Re: CRMC Application File #A2021-09-093
Applicant: William Gilbane
Location: #1159 Succotash Road; Play I-J, Lot 64-2 in Narragansett

Response to comments dated 2/15/22 and update to Variance Request to Section 1.3.1 (D)(11)(k) (intrusion into the 25' extension of abutting property lines) and Section 1.3.1 (D)(11)(l)(length to 67' beyond MLW, a 34% increase beyond the 50' standard)

DOCK PLAN
PREPARED FOR

WILLIAM GILBANE

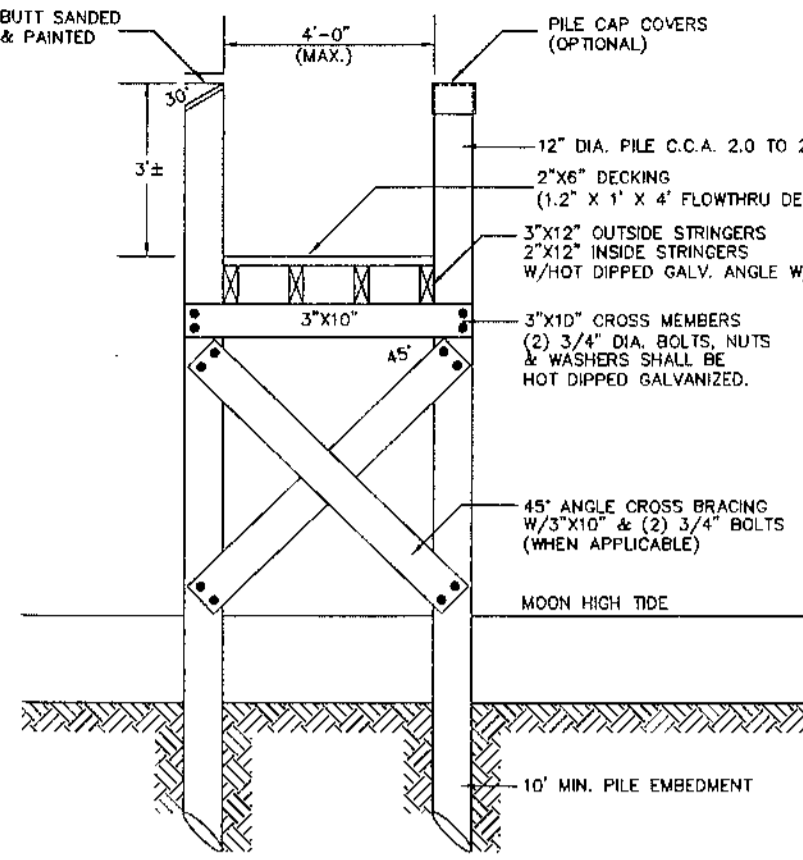
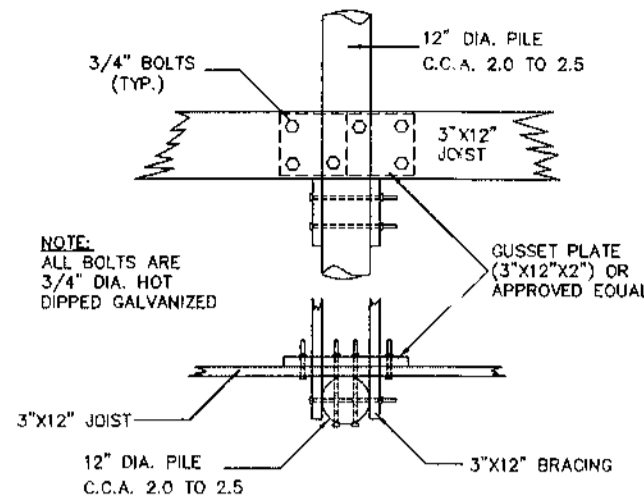
5. Please note that CRMC internal guidance considers 18" to 3' of water depth reasonable for recreational boating. Staff review will balance water depth with length as well as nearby docks (noting substandard/grandfathered/unauthorized designs). A length variance to Section 1.3.1(D)(11)(l) is required for the current design and staff advises the applicant to shorten the proposal as indicated above. Additionally, length to federal channel shall also be depicted. Based on the revised plans, the existing unauthorized dock achieves approximately 2.5' of water at its depth at a distance of 46' seaward of MLW. The proposed dock is seeking 4.5' at 73' seaward of MLW. CRMC current regulations consider 3' water depth/50' seaward of MLW reasonable as noted above. Additionally, the proposal extends further over SAV and proposes a prohibited float over SAV (see below). As such, staff does not support the current layout and recommends the applicant shorten the facility to 3' water depth, lessening both the length and SAV variances required.

8. A Special Exception is required for a float over SAV, which includes a compelling public purpose. Staff does not support a Special Exception for this project and recommends the float be removed; An "L" or "T" terminus could be pursued instead. Staff also recognizes the pre-existing nature (although unauthorized) of this area for docking and can support a new structure over SAV in this location if redesigned consistent with above comments.
-

As part of the revised Dock Plan, we have replaced the proposed float with a 12.5' x 14.0' boat lift, which is allowed in Type 5 waters, and the dock will not impact SAV as significantly as the previous application. Though it has been requested to shorten to 3' water depth MLW, based on manufacturer's recommendations for the Hi-Tide Gear Drive Lift, a minimum 24" of clearance is needed between the bottom of the aluminum bunks and the top of water to reliably lift the boat from the water. While 24" should be sufficient at -3' MLW, we are requesting a depth of -4' MLW to further minimize impact to SAV (making sure that the beams do not rest on the bottom when lifting the boat).

The float has been replaced by a boat lift, as discussed in comment #5. This revision was done to minimize impacts to SAV.

PER MANUFACTURER RECOMMENDATIONS, 24" DEPTH CLEARANCE NEEDED FROM TOP OF WATER TO BOTTOM OF BEAM
